ADDENDUM

PROJECT: DOT-200009 Putnam County FSMF

ADDENDUM NO.: 2

PUTNAM COUNTY FSM FACILITY FOR OHIO DEPARTMENT OF TRANSPORTATION

REVISION SCHEDULE	
Δ	02/28/2025 - ADDENDUM #2
ISSUE DATE: 02/12/2025	
JOB NUMBER: 240659	
BID DOCUMENTS	
<div style="border: 2px solid red; border-radius: 50%; padding: 10px; display: inline-block;"> C4.3 <small>GRADING PLAN</small> </div>

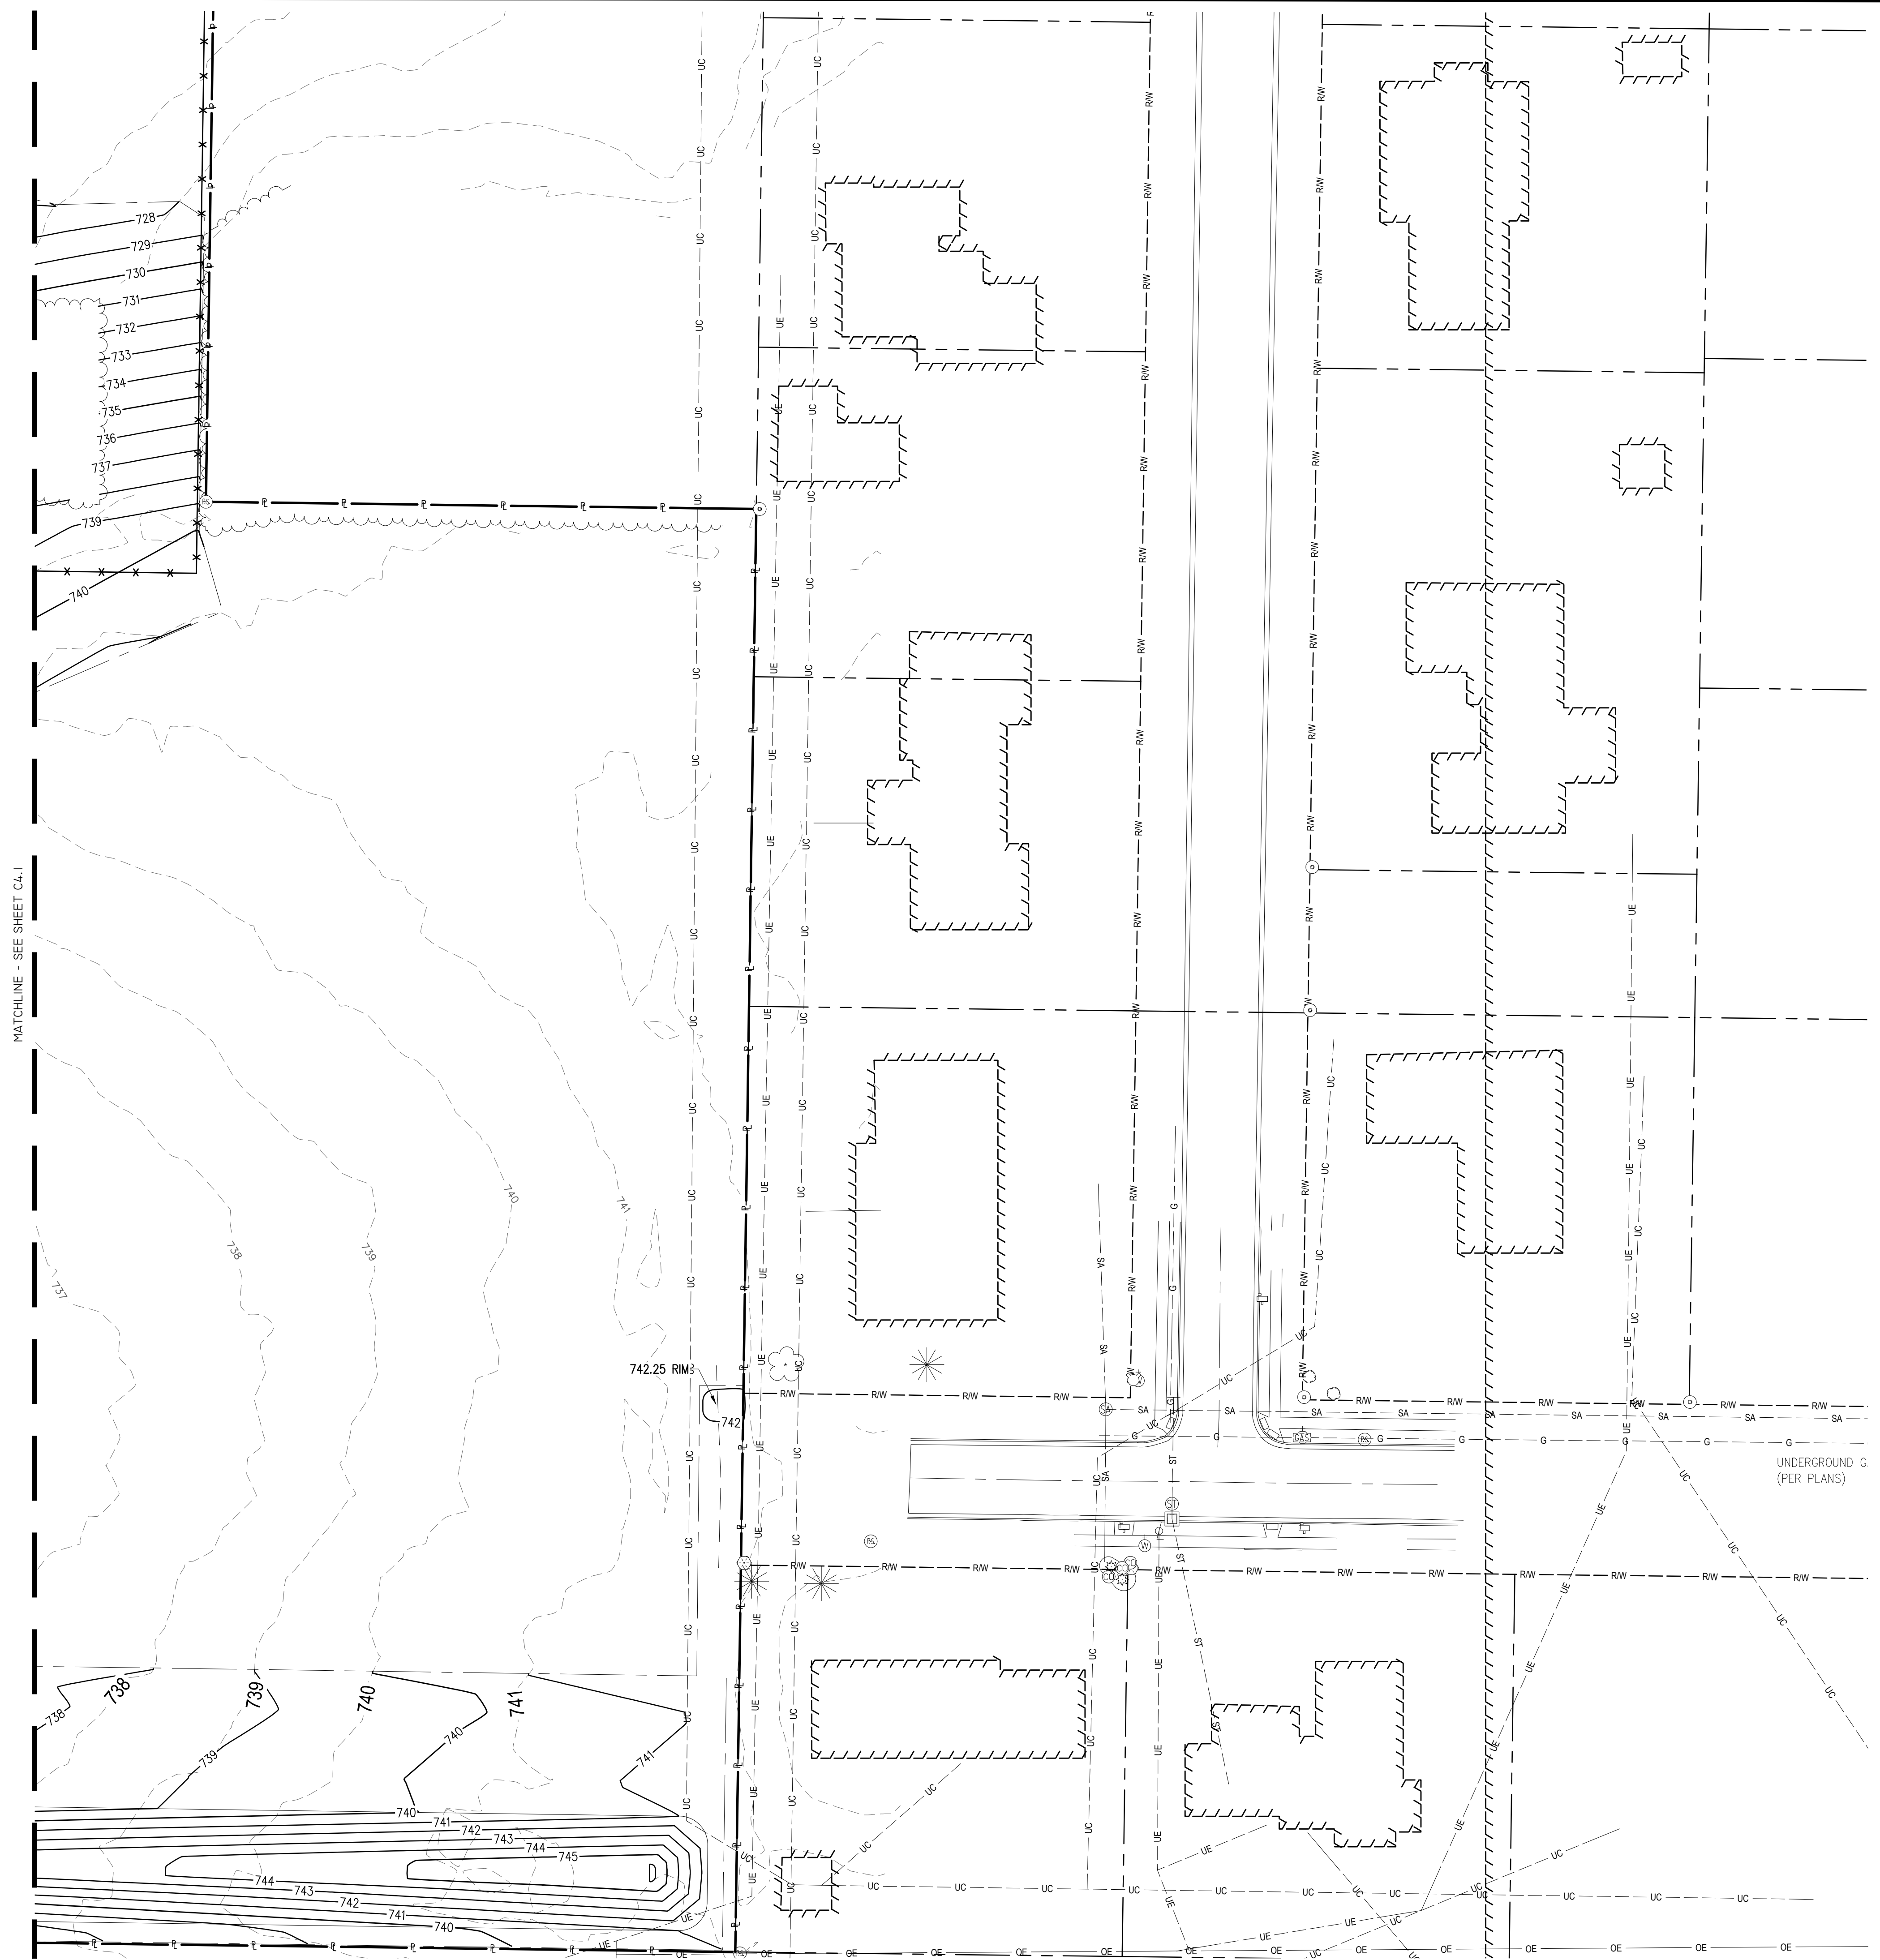
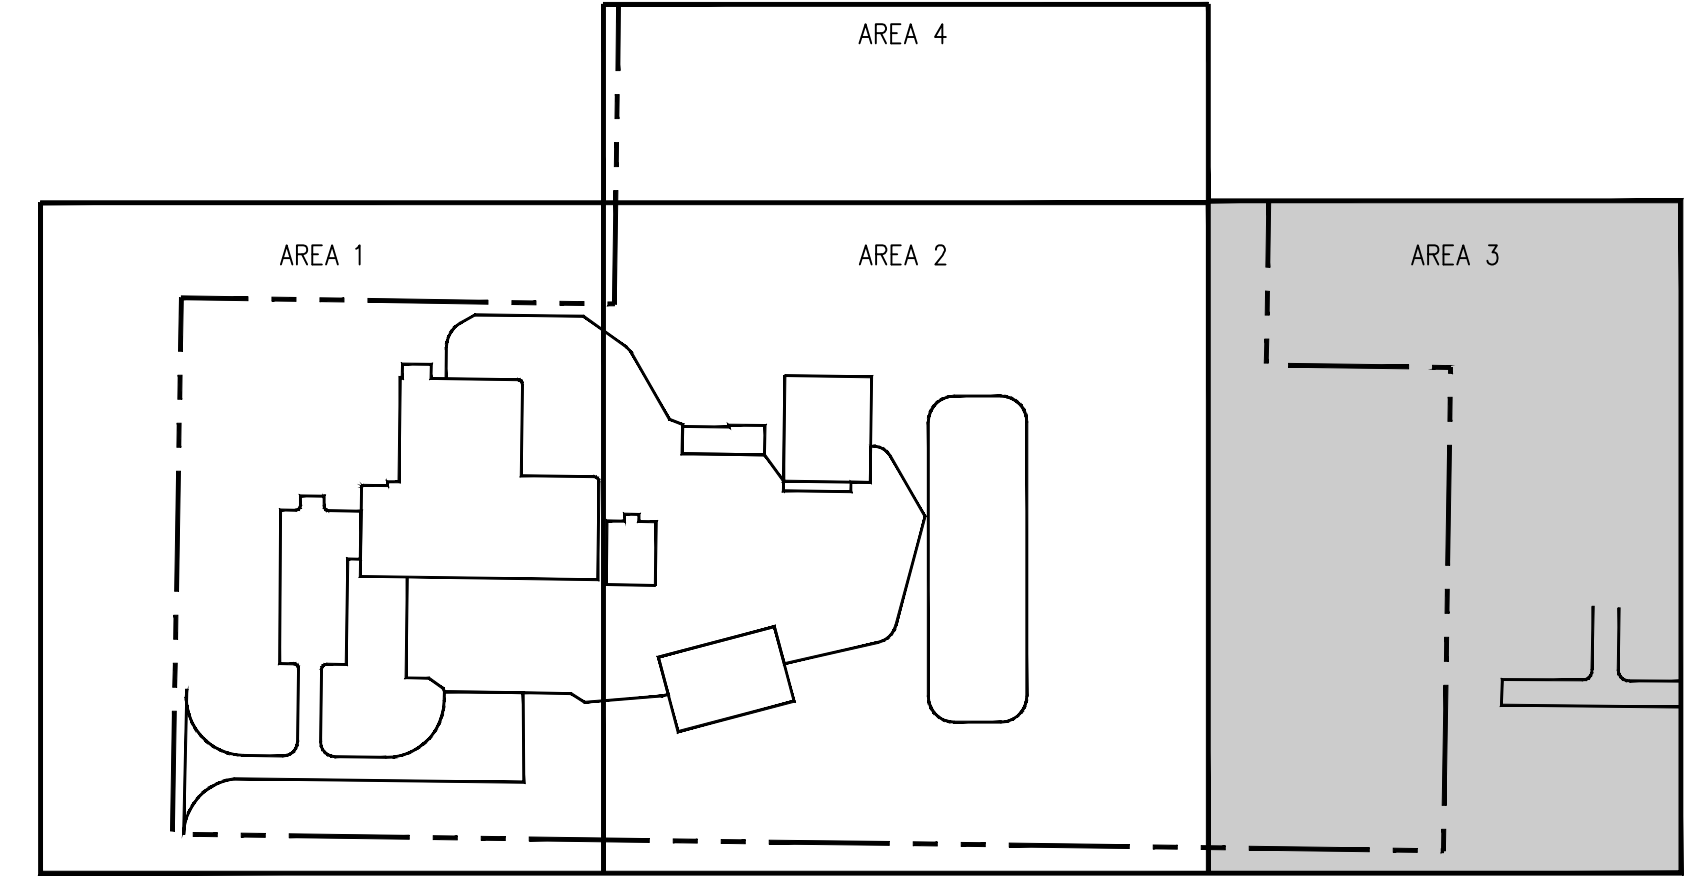
- Revision: This sheet re-numbered, previously sheet C4.2

C5.2
STORMWATER POLLUTION
PREVENTION PLAN

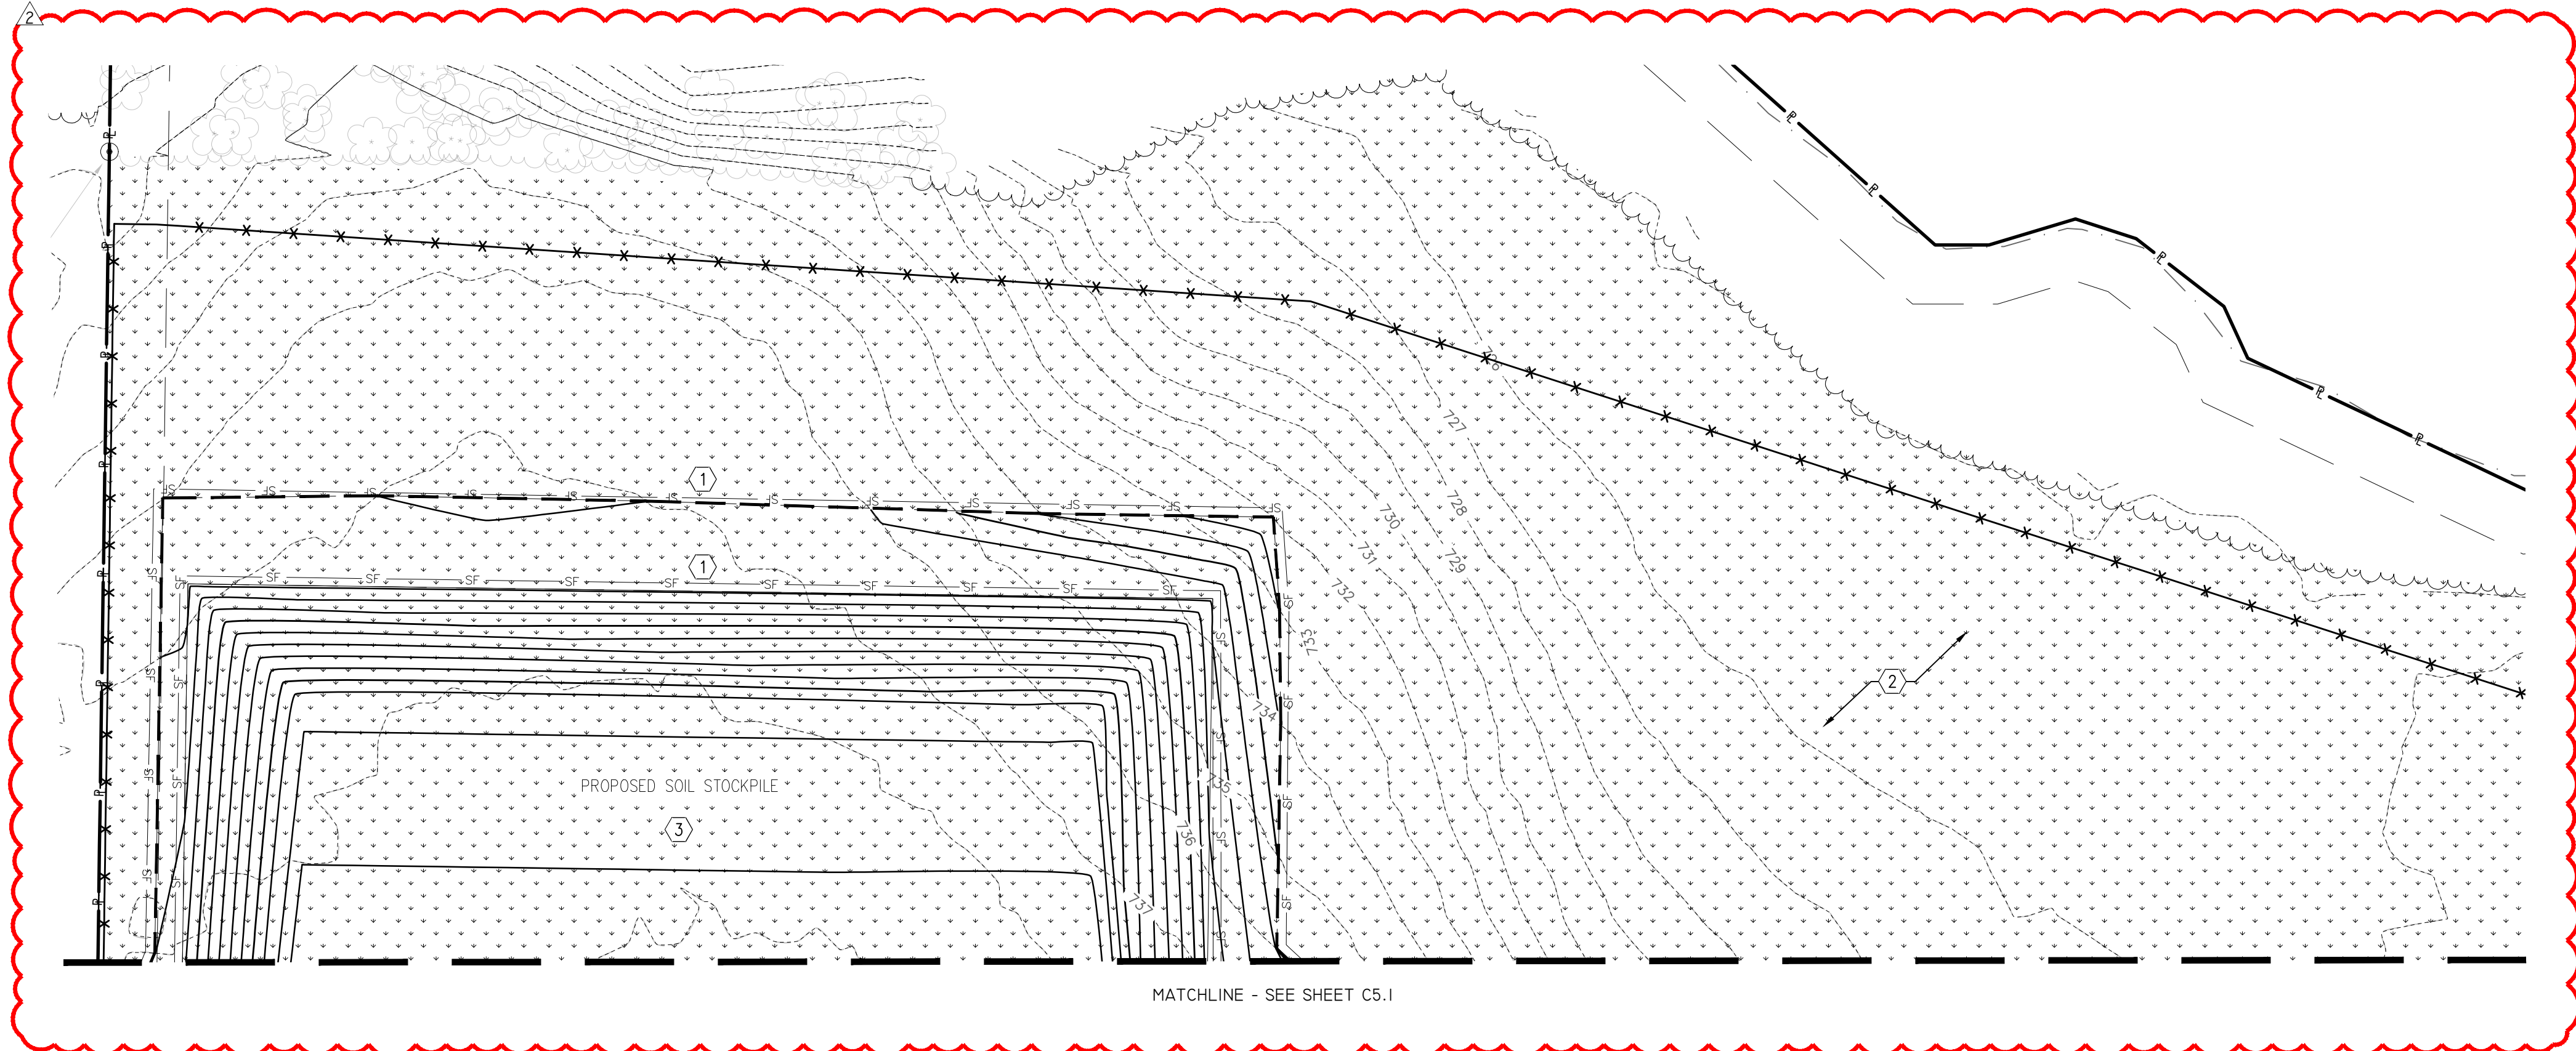
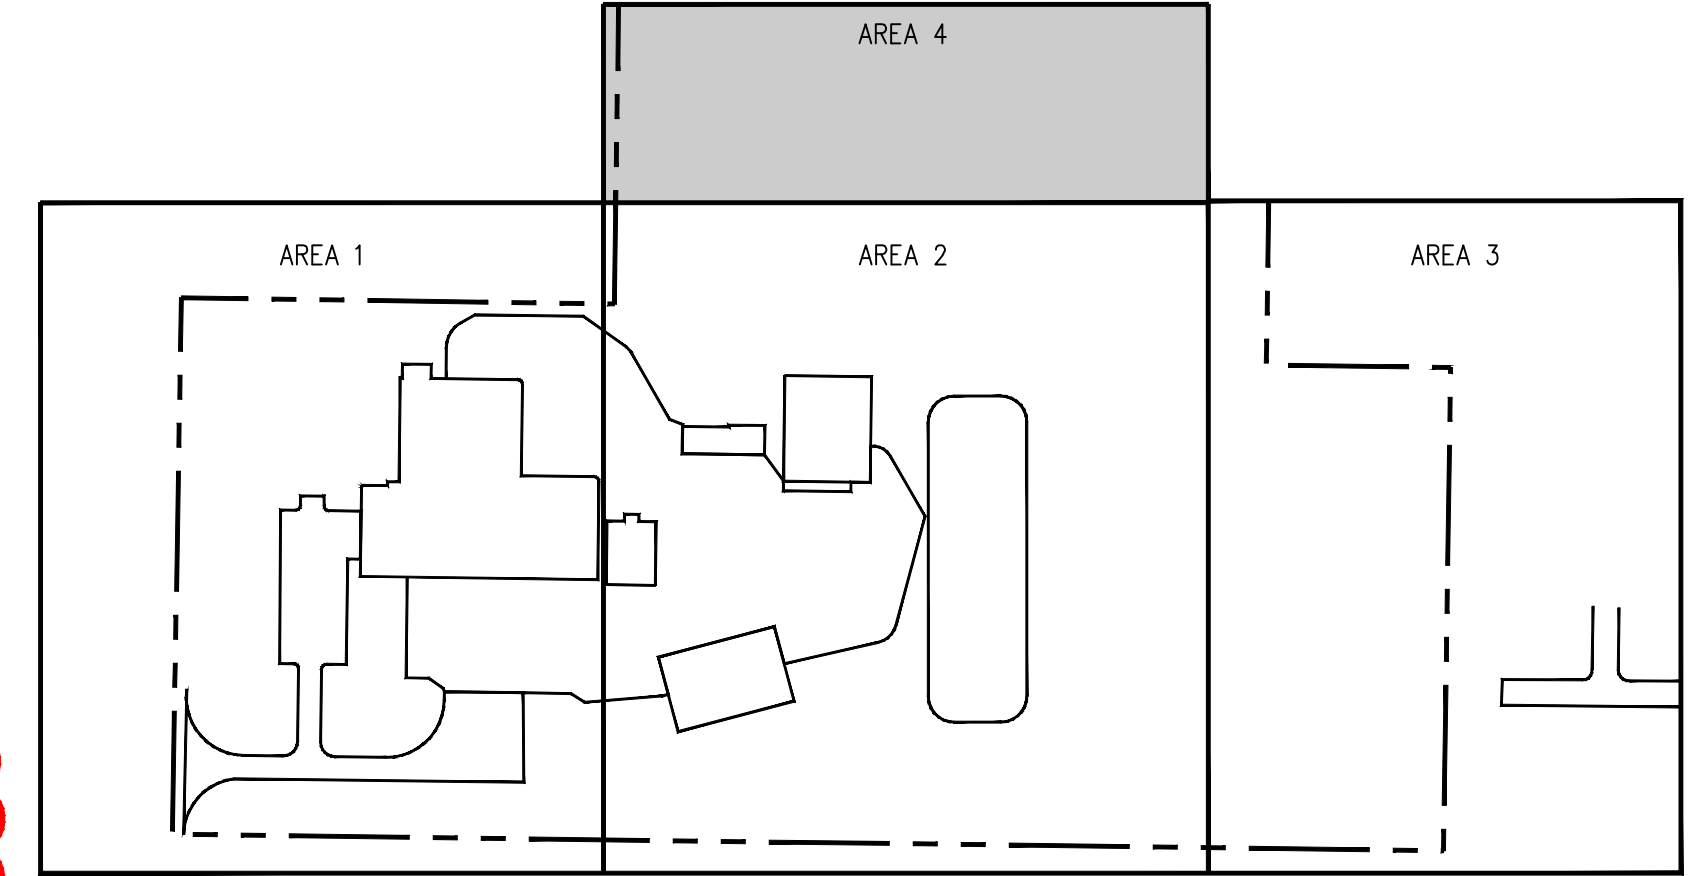
- Revision: This sheet added to capture northern portion of stockpile grading limits
